UNITED STATES PATENT AND TRADEMARK OFFICE

APPLICATION NO.	FILING DATE	FIRST NAMED INVENTOR	ATTORNEY DOCKET NO.	CONFIRMATION NO.
10/727,306	12/03/2003	Douglas B. Wilson	114089.120	5202
23483	7590	03/30/2006	EXAMINER	
WILMER CUTLER PICKERING HALE AND DORR LLP 60 STATE STREET BOSTON, MA 02109			LUONG, VINH	
			ART UNIT	PAPER NUMBER
			3682	
DATE MAILED: 03/30/2006

Office Action Summary

ATTACHMENT # 1

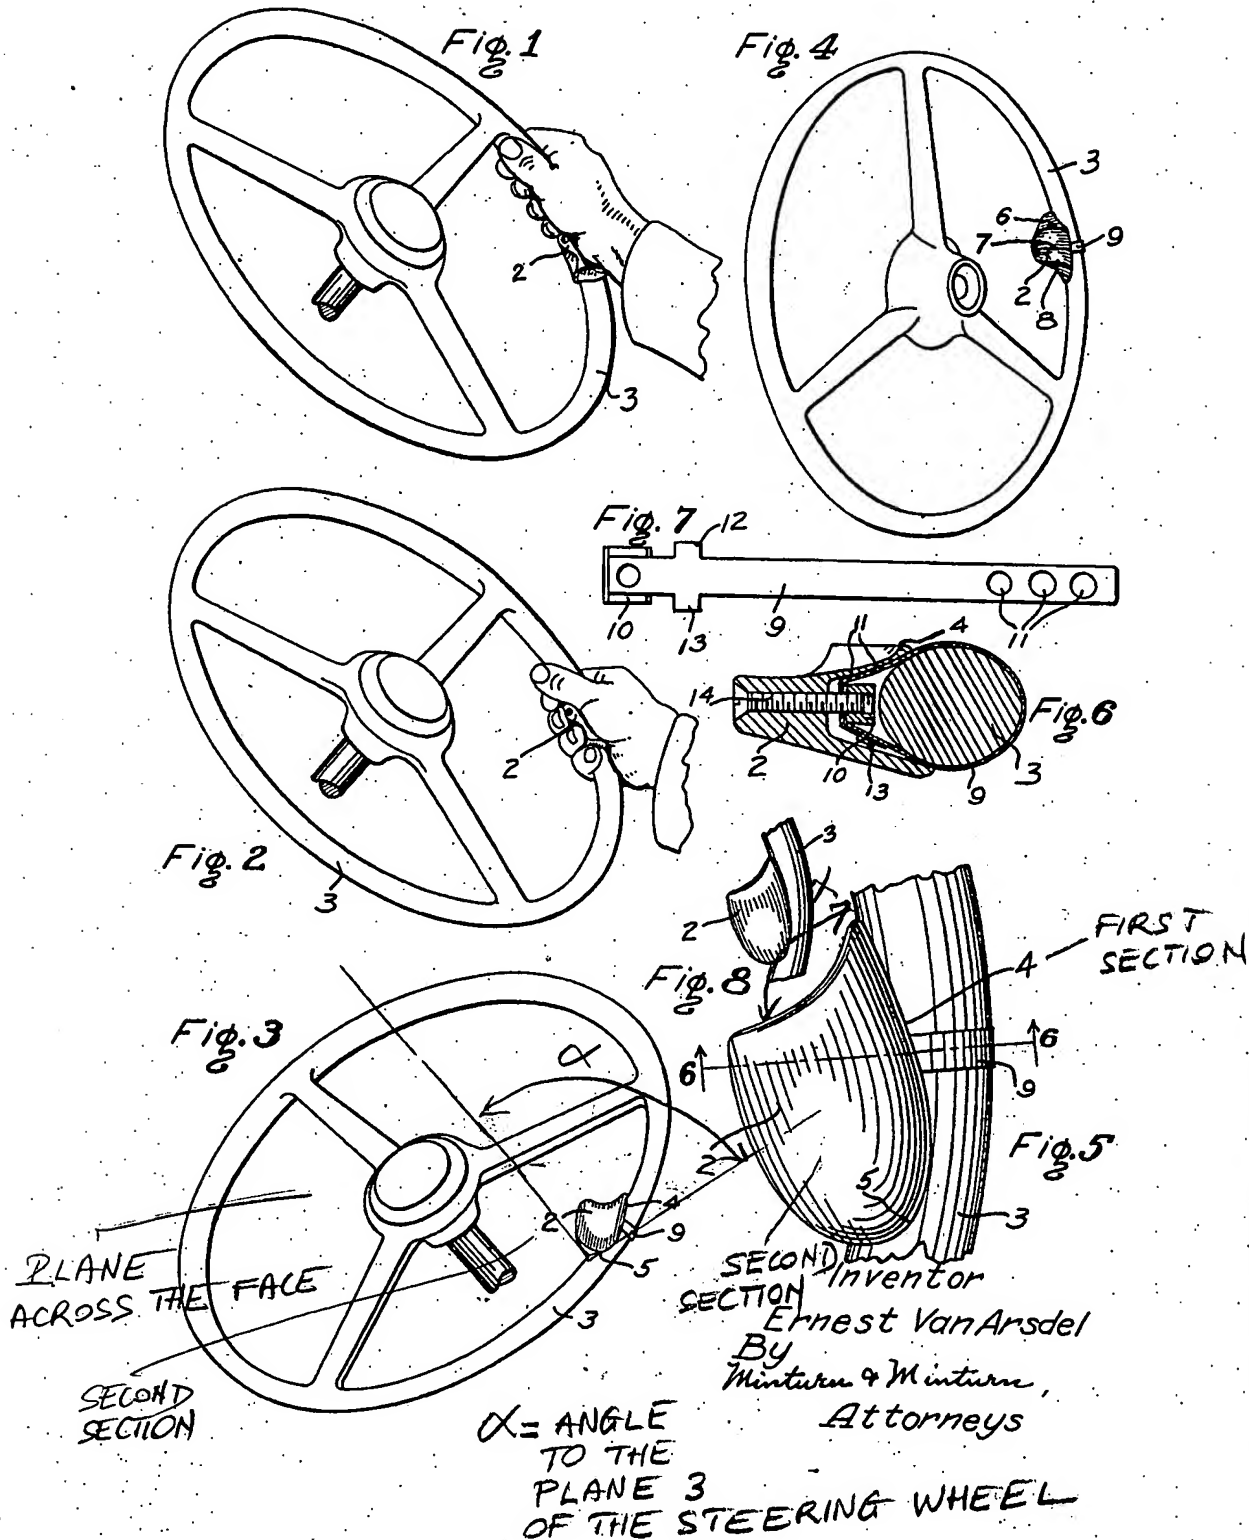
Regarding claim 14, Van Arsdell teaches a fatigue relieving/preventing apparatus associated with a steering wheel 3 for controlling a vehicle, comprising:

a first section 4 (i.e., a horizontal section) that connects to a peripheral portion of the steering wheel 3; and

a rigid, semi-rigid or flexible, or non-deformable second section 2 that connects to, and extends from the first section 4 at the peripheral portion of the steering wheel 3, the second section 2 extends from the first section 4 outward at an angle (see angle α in Figs. 3 and 5 of Attachment 1) to a plane (Att. 1) across a front face of the steering wheel 3, the second section 2 for supporting at least a portion of a vehicular operator's body when pressure from the portion of the vehicular operator's body on the second section 2 is less than the pressure for deforming the second section 2 out of interference with the vehicular operator's ability to operate the steering wheel 3, and deforming out of interference with the vehicular operator's ability to operate the steering wheel 3 when pressure from the portion of the vehicular operator's body on

the second section 2 is equal to or greater than the pressure for deforming the second section 2 out of interference with the vehicular operator's ability to operate the steering wheel 3.

The instant Office action only uses Laubach, Anson, and Van Arsdel. Each of these references teaches the second section disposed outward at an angle to the plane across the face of the steering wheel as seen in Attachments 1-3. Therefore, the elected claims 14-19, 24/14 and 27

ATTACHMENT # 2

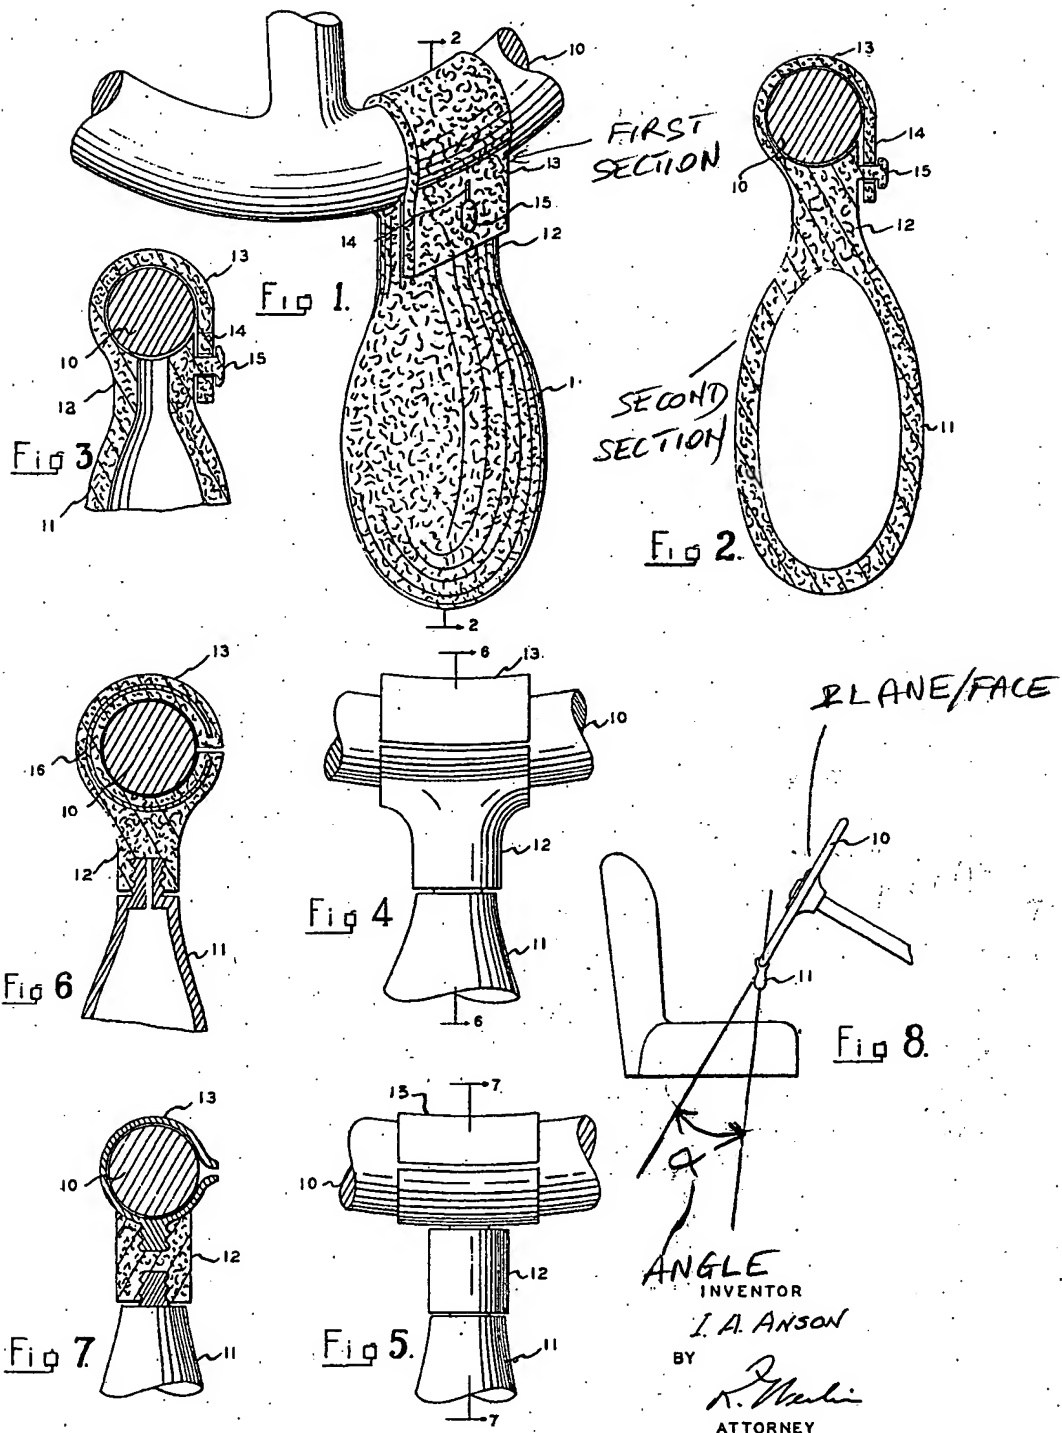
Regarding claim 14, Anson teaches a fatigue relieving/preventing apparatus associated with a steering wheel 10 for controlling a vehicle, comprising:

a first section 13 that connects to a peripheral portion of the steering wheel 10; and
a rigid, semi-rigid or flexible, or non-deformable second section 11 that connects to, and extends from the first section 13 at the peripheral portion of the steering wheel 10, the second section 11 extends from the first section 13 outward at an angle (see angle α in Fig. 8 of Attachment 2) to a plane (Att. 2) across a front face of the steering wheel 10, the second section 11 for supporting at least a portion of a vehicular operator's body when pressure from the portion of the vehicular operator's body on the second section 11 is less than the pressure for deforming the second section 11 out of interference with the vehicular operator's ability to operate the steering wheel 10, and deforming out of interference with the vehicular operator's ability to operate the steering wheel 10 when pressure from the portion of the vehicular operator's body on the second section 11 is equal to or greater than the pressure for deforming the second section 11 out of interference with the vehicular operator's ability to operate the steering wheel 10.

ATTACHMENT # 3

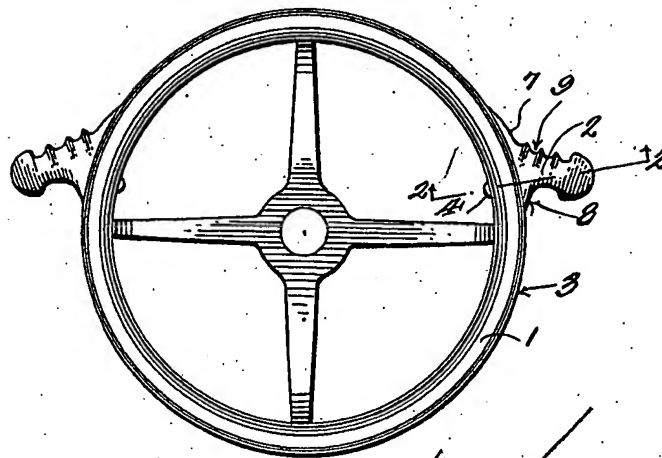
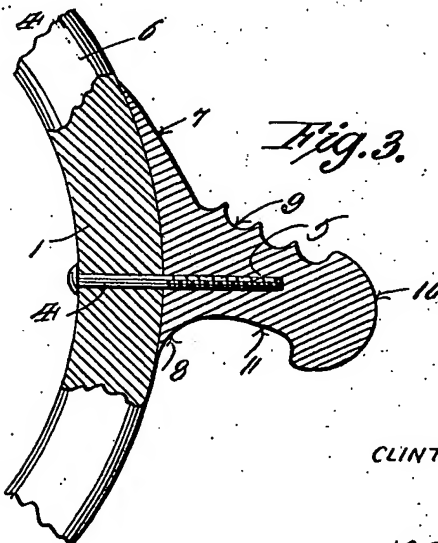
Regarding claim 14, Laubach teaches a fatigue relieving/preventing apparatus associated with a steering wheel 1 for controlling a vehicle, comprising:

a first section 7, 8 that connects to a peripheral portion of the steering wheel 1; and
a rigid, semi-rigid or flexible, or non-deformable second section 10 that connects to, and extends from the first section 7, 8 at the peripheral portion of the steering wheel 1, the second section 10 extends from the first section 7, 8 outward at an angle (see angle α in Fig. 2 of Attachment 3) to a plane (Att. 3) across a front face (Att. 3) of the steering wheel 1, the second section 10 for supporting at least a portion of a vehicular operator's body when pressure from the portion of the vehicular operator's body on the second section 10 is less than the pressure for deforming the second section 10 out of interference with the vehicular operator's ability to operate the steering wheel 1, and deforming out of interference with the vehicular operator's ability to operate the steering wheel 1 when pressure from the portion of the vehicular operator's

body on the second section 10 is equal to or greater than the pressure for deforming the second section 10 out of interference with the vehicular operator's ability to operate the steering wheel 1.

Regarding claim 18, the second section 10 includes at least two second sections (Fig. 1) that each connect to the first section 7, 8 at separate locations.
